IEEE P802.15
Wireless Personal Area Networks

Project	IEEE P802.15 Working Group for Wireless Personal Area Networks (WPANs)	
Title	TG3 LB19 comment resolution	
Date Submitted	[12 September, 2002]	
Source	[James P. K. Gilb] [Apparent Technologies] [9921 Carmel Mountain Rd. #247, San Diego, CA 92129]	Voice: [858-538-3903] Fax: [858-538-3903] E-mail: [gilb@ieee.org]
Re:	[]	
Abstract	[This document is a record of comment resolutions for LB19.]	
Purpose	[To provide a record of the comment resolution for LB19.]	
Notice	This document has been prepared to assist the IEEE P802.15. It is offered as a basis for discussion and is not binding on the contributing individual(s) or organization(s). The material in this document is subject to change in form and content after further study. The contributor(s) reserve(s) the right to add, amend or withdraw material contained herein.	
Release	The contributor acknowledges and accepts that this contribution becomes the property of IEEE and may be made publicly available by P802.15.

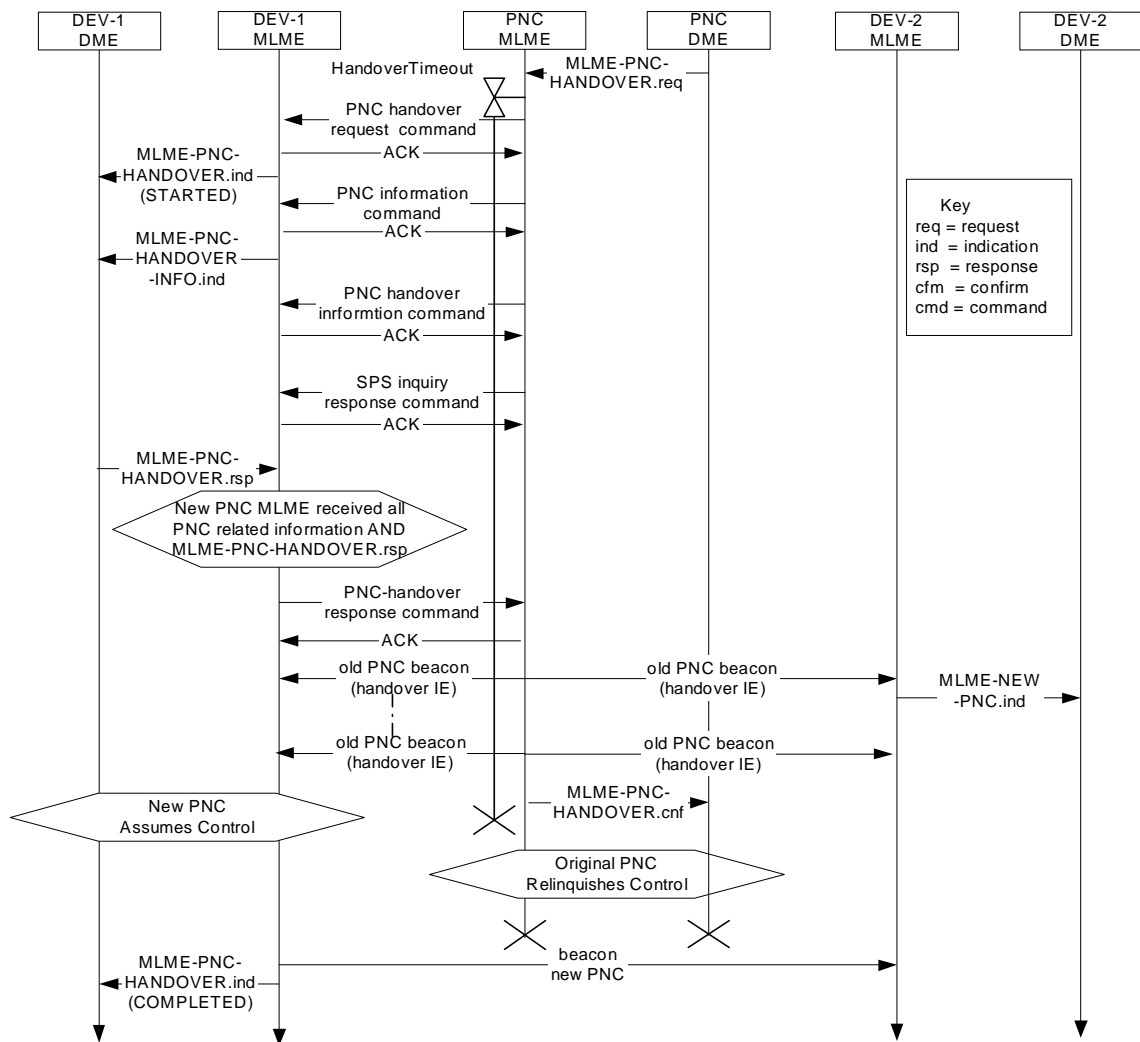
269 (Heberling, TR) - [PNCHndOvr] Some errors in text remain or were introduced after LB17.MSC in Figure 91 is also wrong./KO Text changes for 8.2.3 and ne MSC for Figure 91 are all collected in:02276r7P802-15_TG3-commentsD11_KO.doc, Resolution [03]. **Suggest accept in principle**, "The MSC will be modified as indicated in the resolutions of CID 58 and 232. Make the following text changes: In 6.3.13.4, page 59, line 45, change 'This primitive informs the originating DME its request for information from the PNC is complete.' to be 'This primitive informs the DME that the MLME has received a PNC information command, {xref 7.5.4.2}.' In 7.5.3.1, page 138, line 20 'the number of information records to be transferred using the PNC information command frame(s).' to be 'the number of information records that will be transferred from the old PNC to the new PNC.' In 8.2.3 PNC Handover, delete page 156, line 8-9, redundant, same text in

paragraph below. Add to page 156, line 19, 'The PNC handover information command shall not be sent if the PNC has indicated in the PNC handover request command that it does not have any CTRBs to transfer.

The SPS inquiry response command shall not be sent if the PNC has indicated in the PNC handover request command that it doesn't have any SPS sets to transfer.'

Add to page 156, line 35, 'The new PNC shall broadcast its first beacon as close as possible to the start time of what would have been the old PNC's next beacon. The new PNC shall start sending beacons with the beacon number counter set to one more than the beacon number of the last beacon sent by the old PNC.'

Add page 156, line 40ff, 'The PNC shall ensure that the beacon countdown includes at least one system wake beacon and at least aMaxLostBeacons beacons following that system wake beacon.

Figure 1—PNC handover MSC

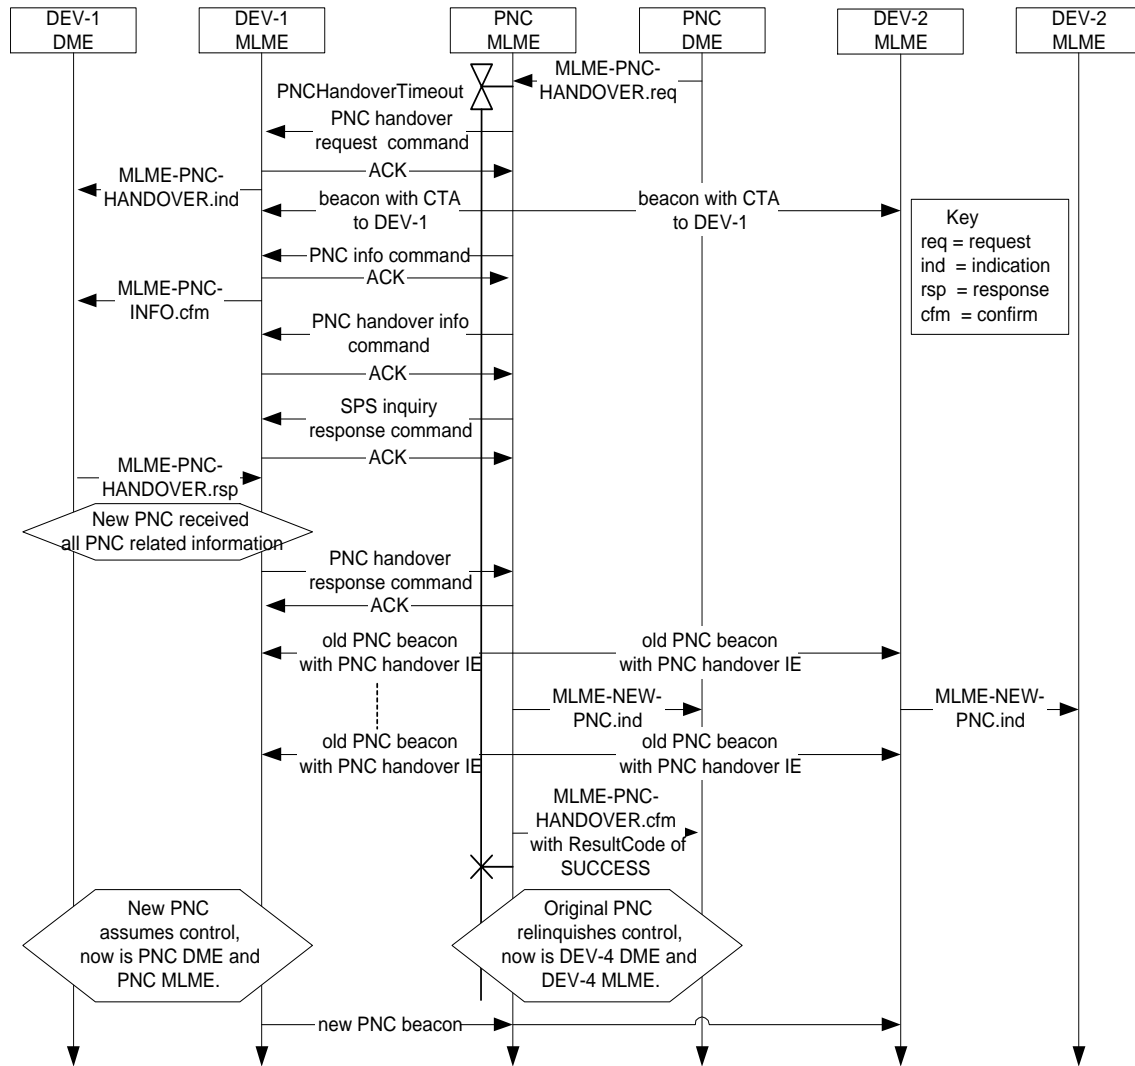
Handover MSC - various comments, suggestion from 02276r7P802-15_TG3-commentsD11_KO.doc below (with some editorial work):

463 (Gubbi, TR) - Figure-91 is a well done job, but the text needs to supplement some info that can not be expressed in the figure, which is incomplete in the current update to this para. It should be mentioned that these commands shall be sent by PNC even if there is no information present that fits into those commands so that the rx-DEV knows the exact end of the transaction. For example, what if there are no DEVs in power save mode. Still the SPS-inquiry-response-command shall be sent by PNC. It should be mentioned that the three commands in Figure-91 (PNC-info-command, PNC-handover-info-command and SPS-inquiry-response-cmd) shall be sent by PNC even if there is no information present that fits into those commands so that the rx-DEV knows the exact end of the transaction. For example, what if there are no DEVs in power save mode. Still the SPS-inquiry-response-command shall be sent by PNC. **Suggest accept in principle.** "Rather than send the empty commands, the PNC handover request will contain the number of CTRBs and SPS sets that will be transferred. If the number of items is zero, then the old PNC shall not send the command and the new PNC will not expect to receive it. It is not possible for the number of DEVs to be less than 2 (i.e. the old PNC and the new PNC), so the PNC information command will always be sent. This is documented in the resolution of CID 269."

Original MSC:.
